Committee of the Whole Report For the Meeting of May 26, 2022

To: Committee of the Whole **Date:** May 13, 2022
From: Karen Hoese, Director, Sustainable Planning and Community Development
Subject: Development Permit with Variances Application No. 00051 for 937 View Street

That Council decline Development Permit with Variances Application No. 00051 for the property located at 937 View Street.

1 Setback Plan - L1
A103 SCALE: 1 : 250

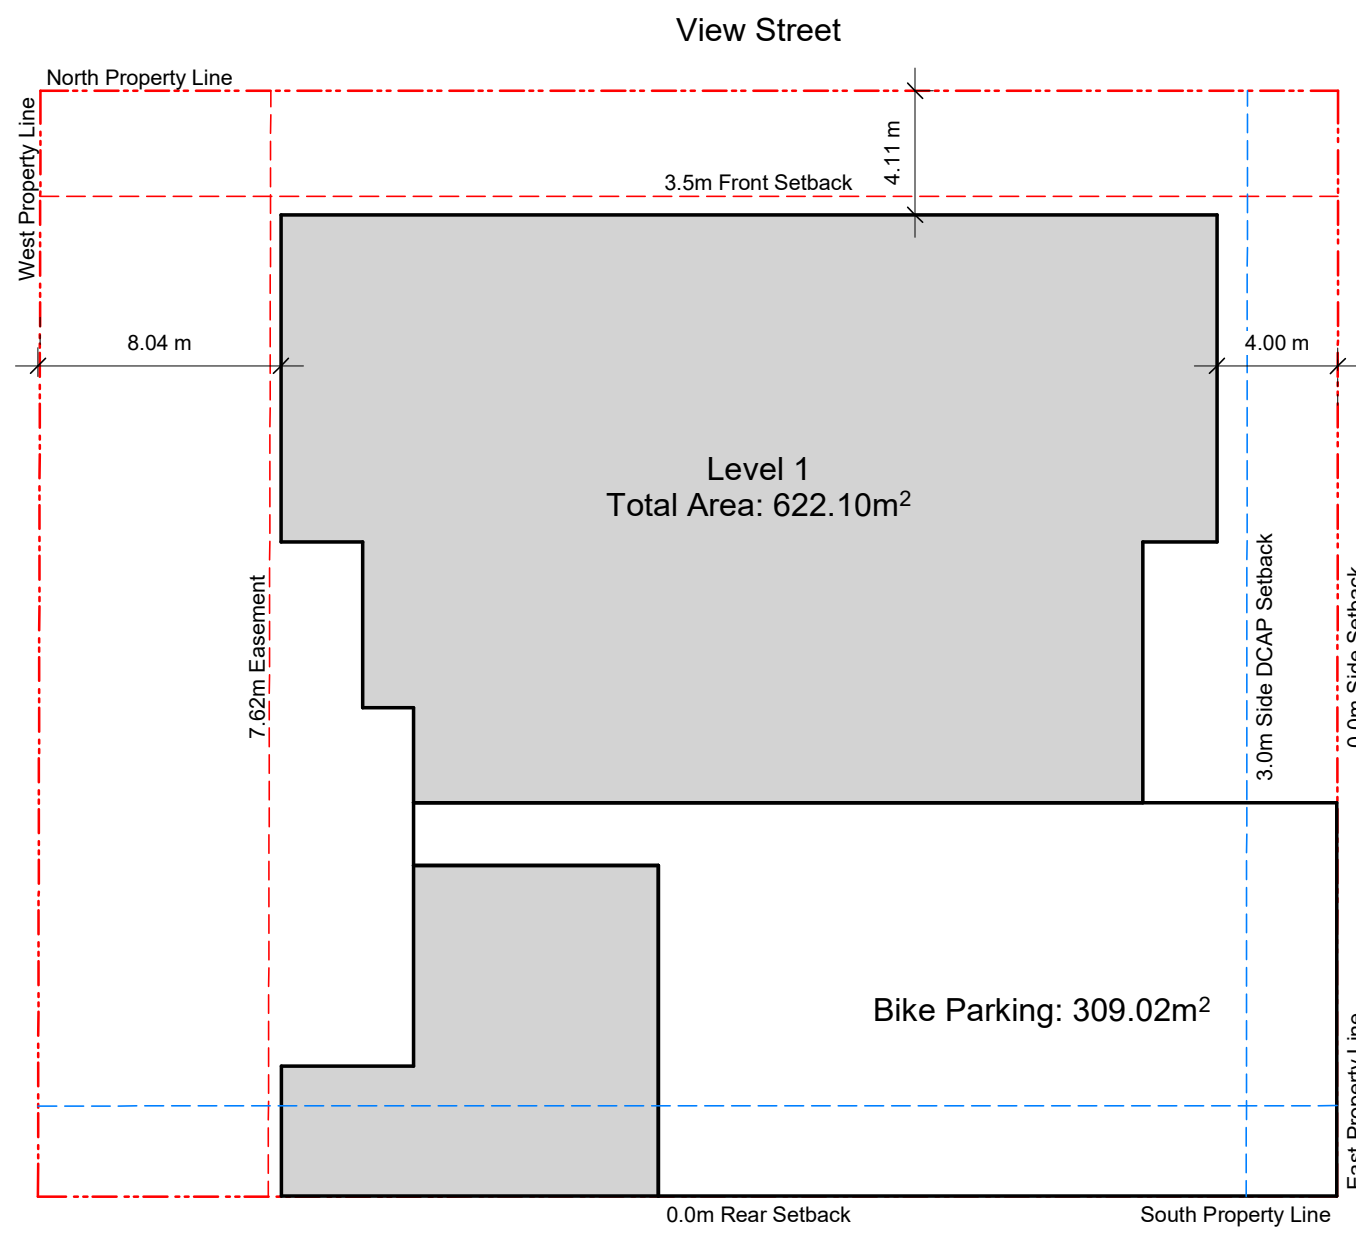
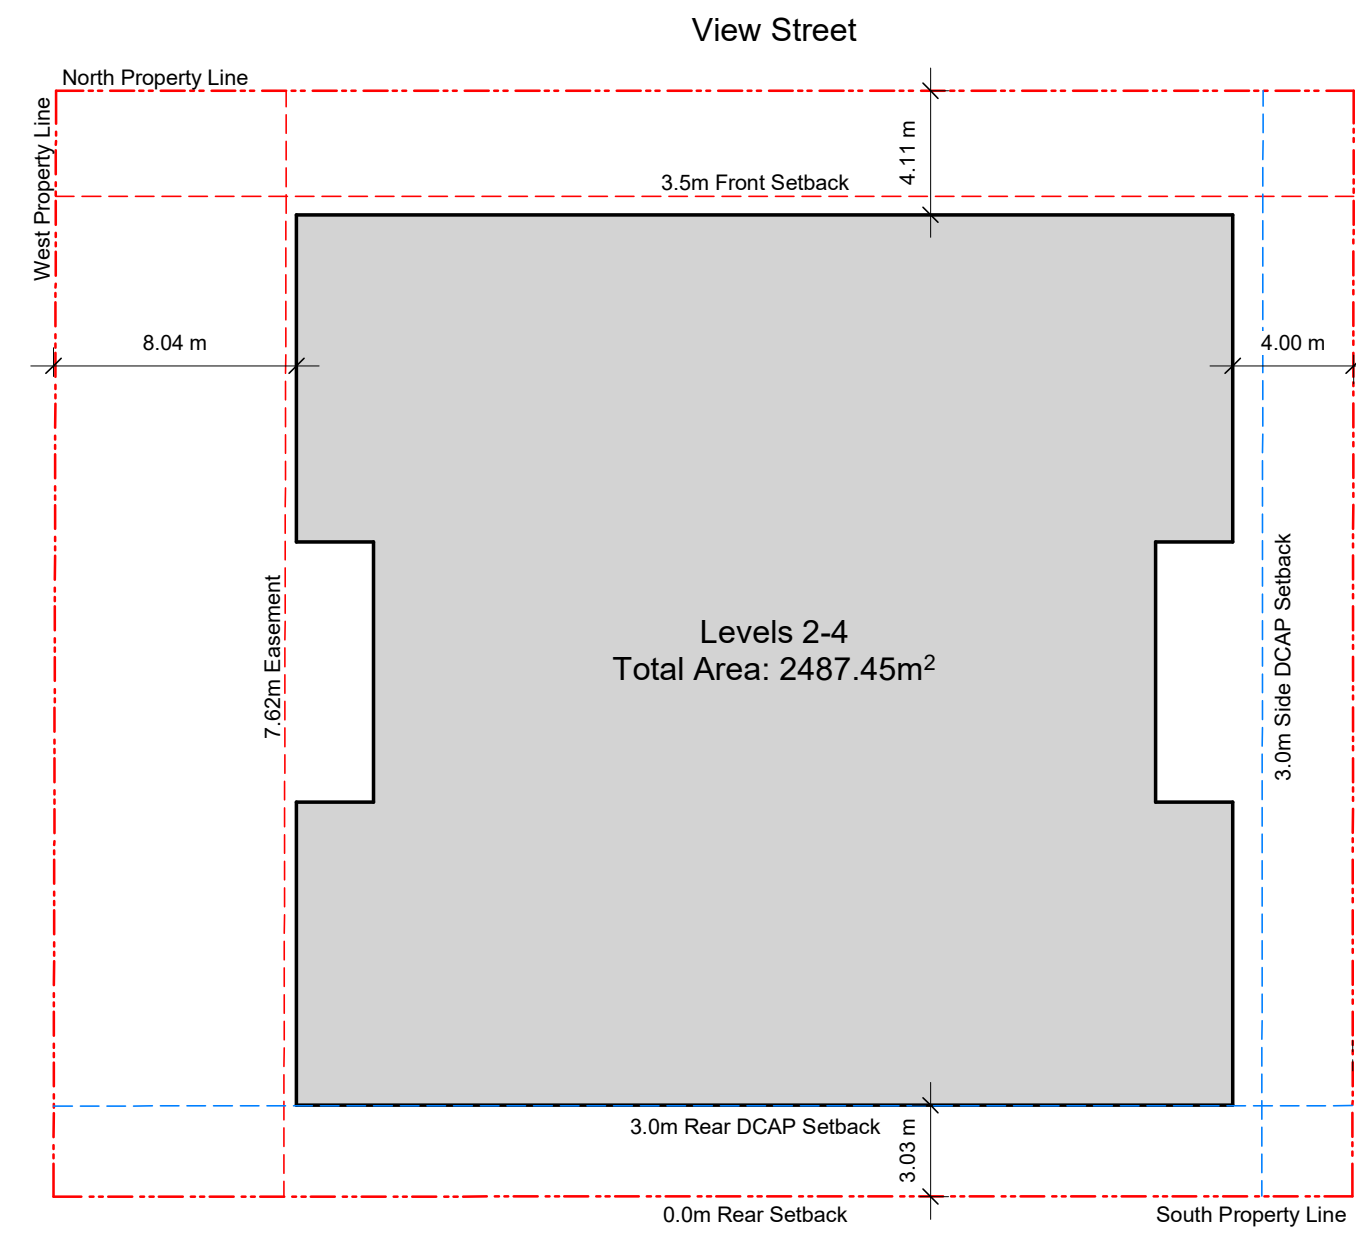
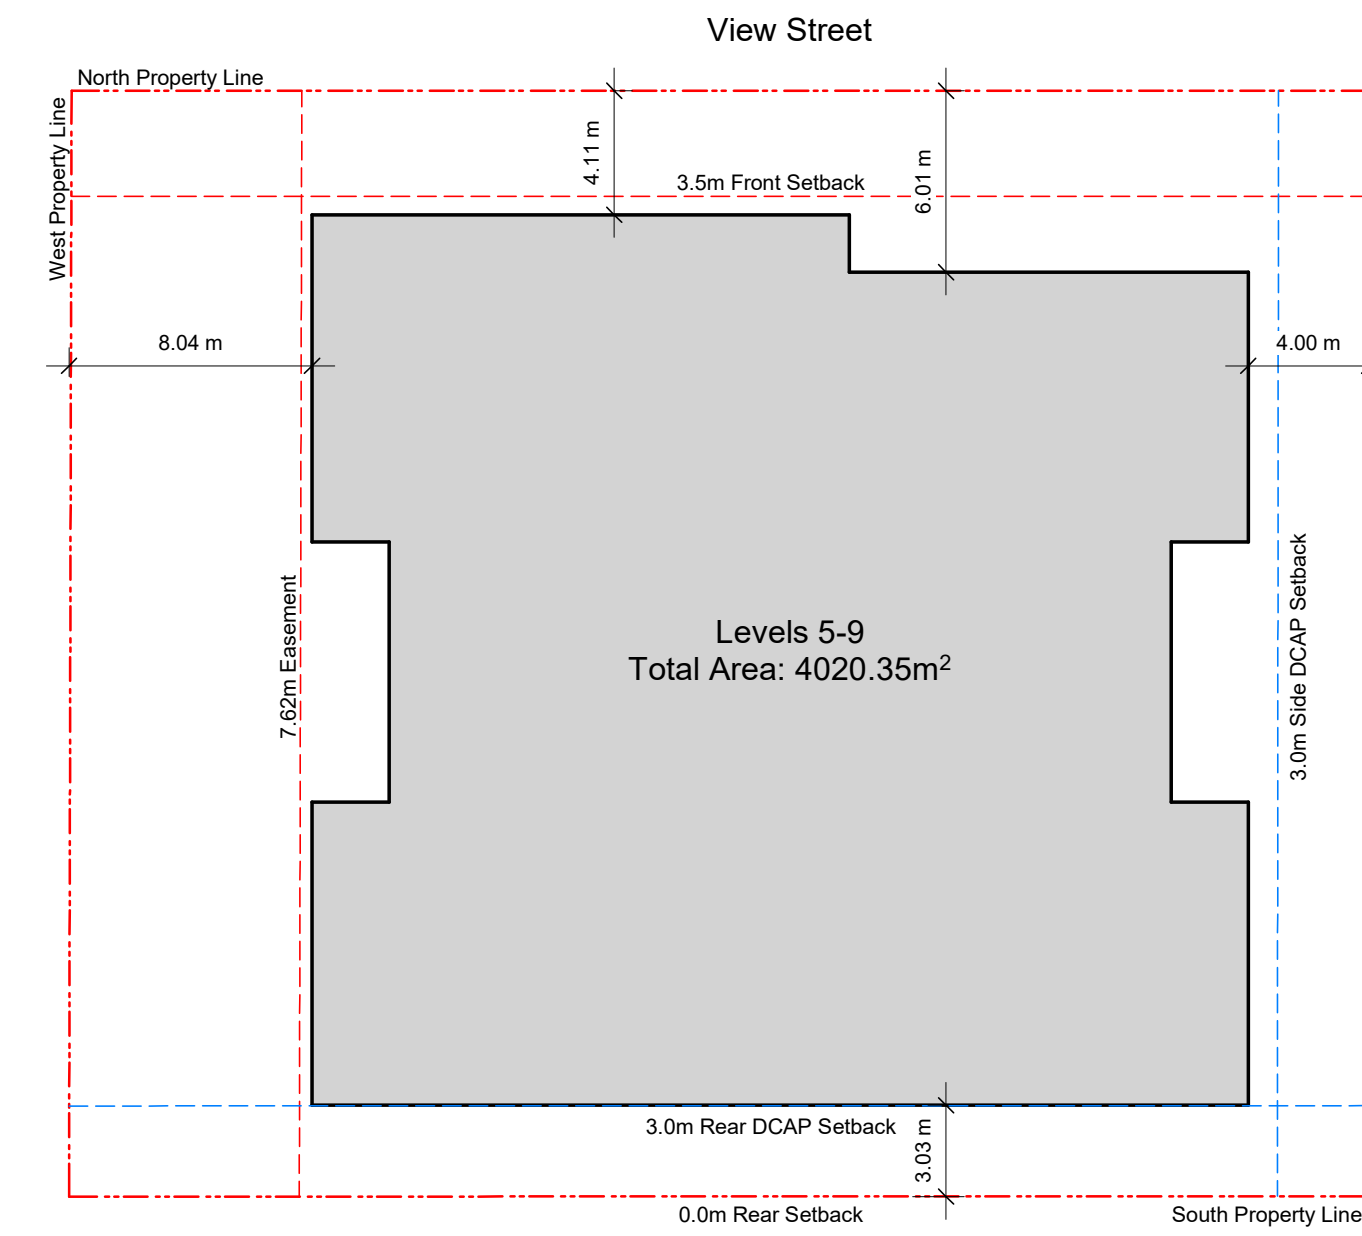
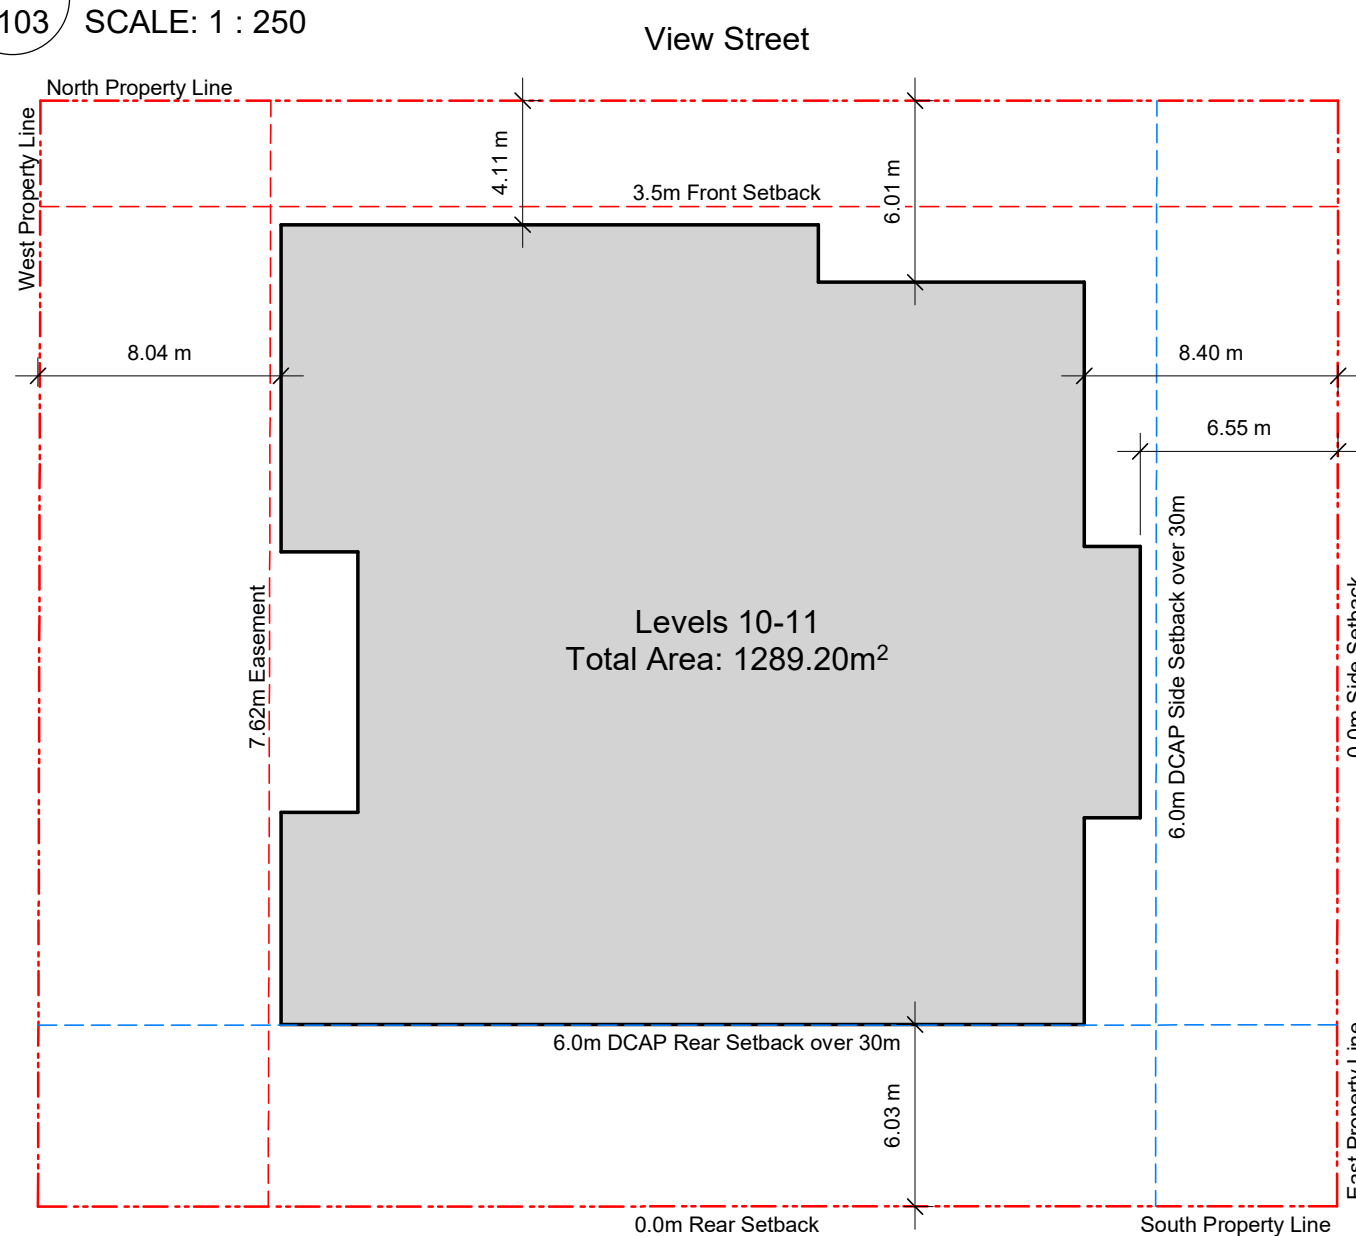
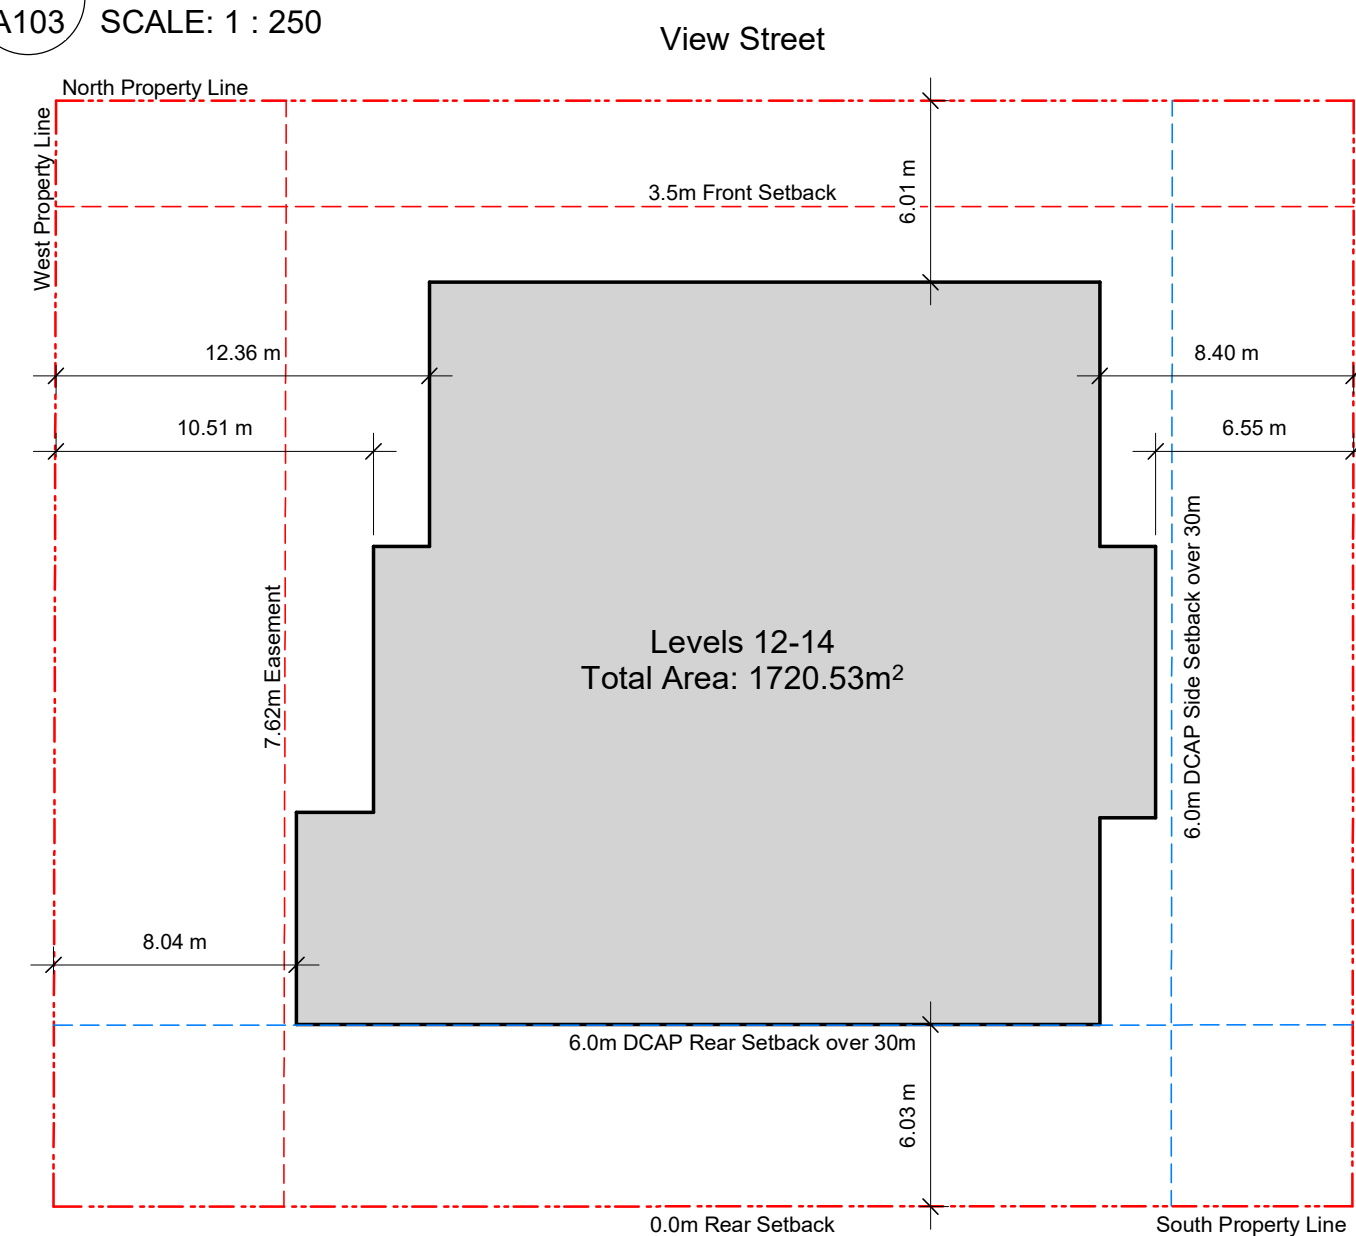
- The upper portions of the tower setbacks on the front (north) do not meet the minimum requirements for street wall heights, with floors 9 to 11 encroaching by approximately 3m.
